SUBJECT: Advises that Figures 1 & 2 were omitted from util 810421 response to NRC 810209 request for addl info on seismic design of standby shutdown facility. Complete response encl.

Re: Oconee Nuclear Station
Docket Nos. 50-269, -270, -287.

REQUEST FOR ADDITIONAL INFORMATION
OCONEE NUCLEAR STATION
DUKE POWER COMPANY
DOCKET NOS. 50-269, 50-270, 50-287

Fig. 1

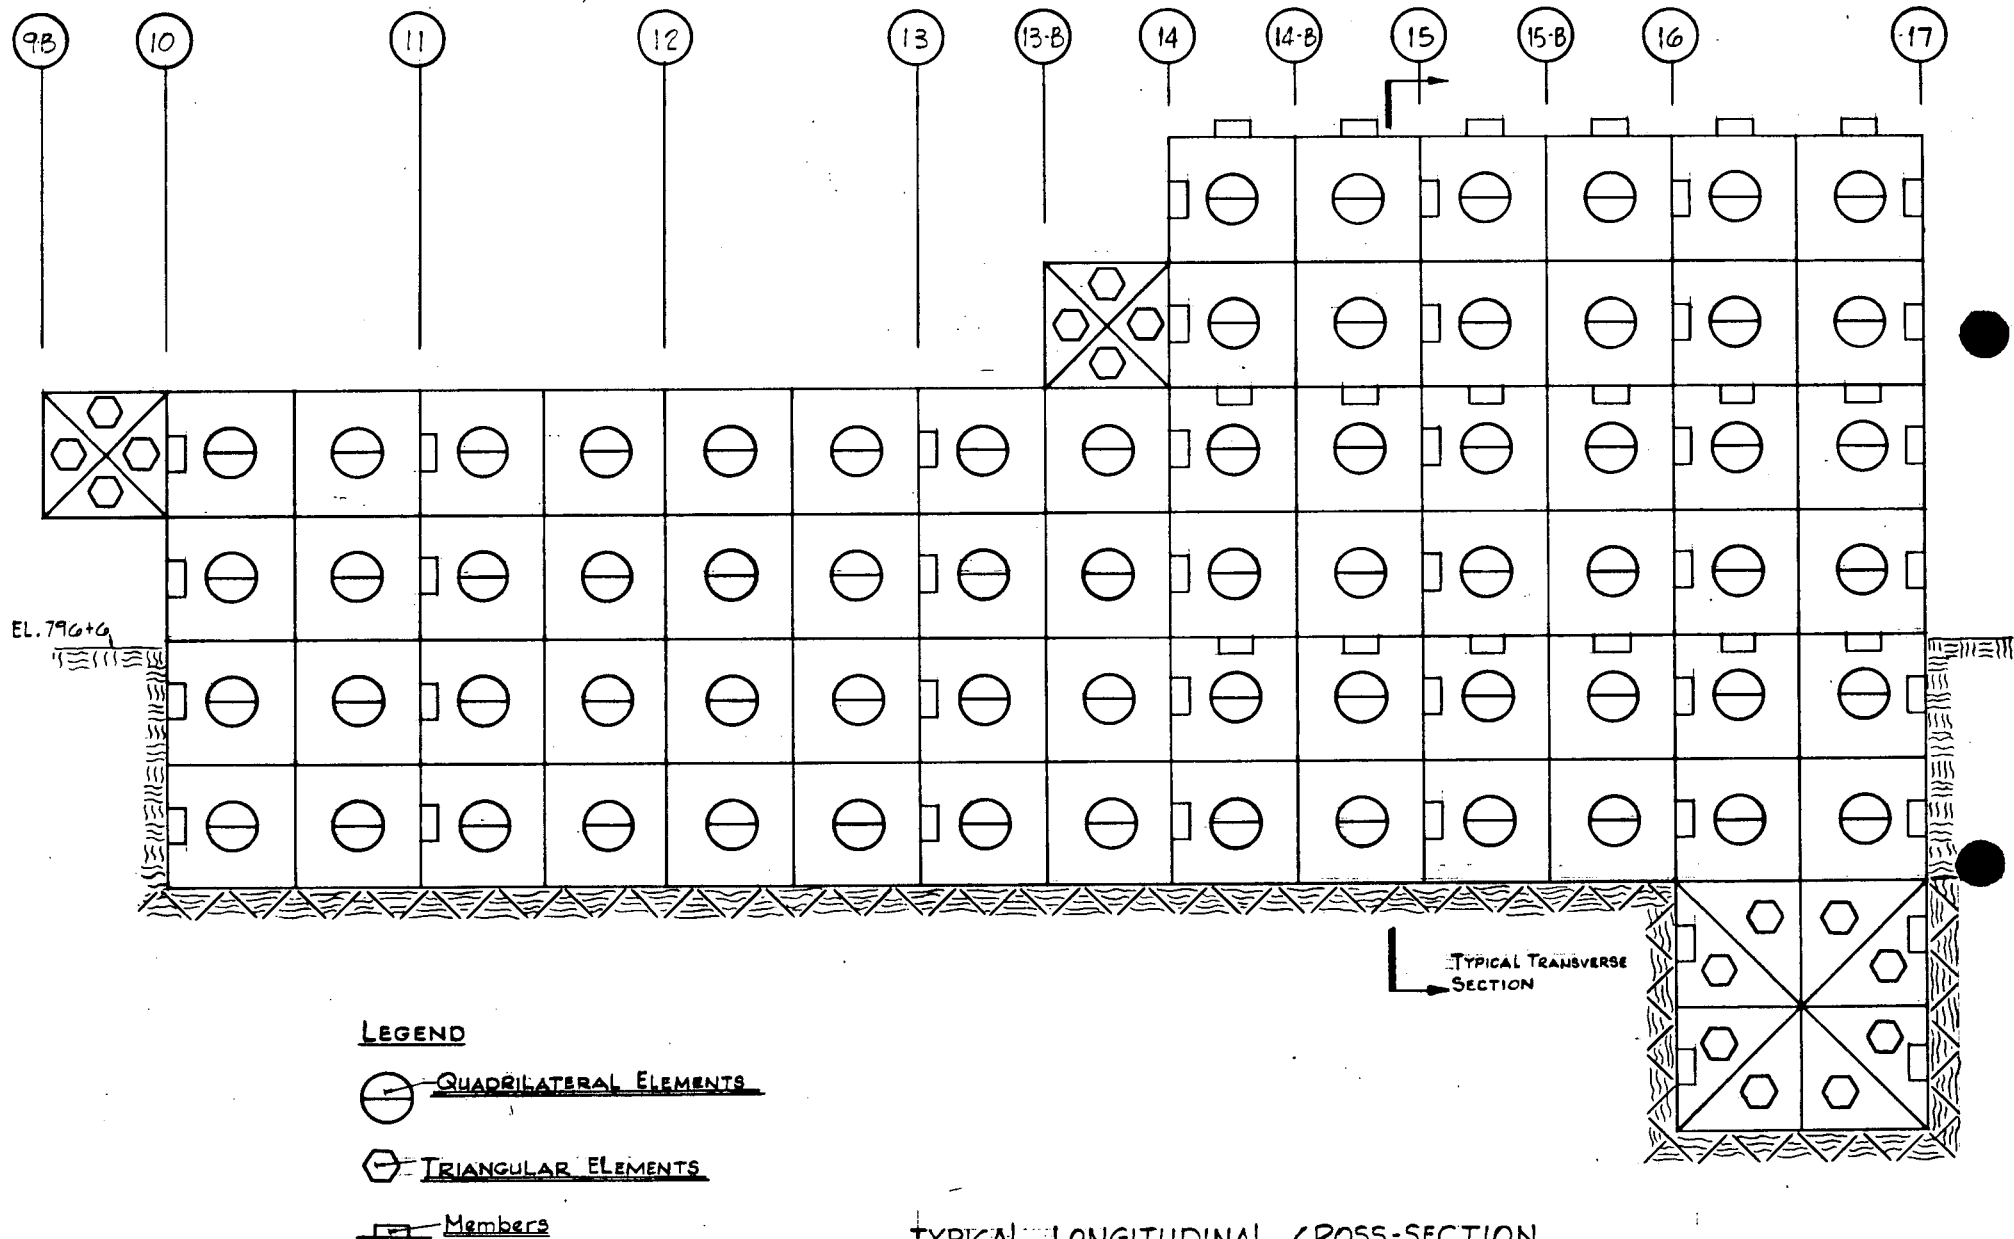
Question 1 - Provide the mathematical model that is used in your earthquake response analysis of SSF. The model should show mass points, their coordinates, damping and spring arrangements and their corresponding numerical values as well as appropriate configurations of soil and bedrock foundation. In particular, provide a reasonable discussion as to how the embedded portion of the building below the ground level is modeled and how soil-structure interaction is considered. If no such soil-structure interaction is considered, please justify the proposed design by discussing why the model without soil-structure interaction represents a conservative dynamic model.

Response - The mathematical model used in the analysis of the Standby Shutdown Facility (SSF) is illustrated in Figures 1 and 2 attached. The model accurately represents the geometry of the structure, and is analyzed both dynamically and statically as a space frame. A damping ratio of .05 (5%) was used in the seismic analysis. One-half of the inertia (mass) of each beam is lumped at each model node. One-quarter of the mass of quadrilateral elements and one-third of the mass of triangular elements are applied to each mass point (model node).

The Standby Shutdown Facility is a reinforced concrete structure erected on continuous rock. The rock properties are similar to those used for the soil-structure interaction analysis for the Catawba Nuclear Station (Reference: Catawba Nuclear Station PSAR, 3.7.1.6, Docket Nos. 50-413 and 50-414). Since the structures at the two stations are similar, the results of the interaction analysis for Catawba are also applicable here. It was concluded in the Catawba analysis that the effect of soil-structure interaction on the frequencies and mode shapes was small and can be neglected. Consequently, for the purpose of seismic analysis, the structure is considered with a fixed base.
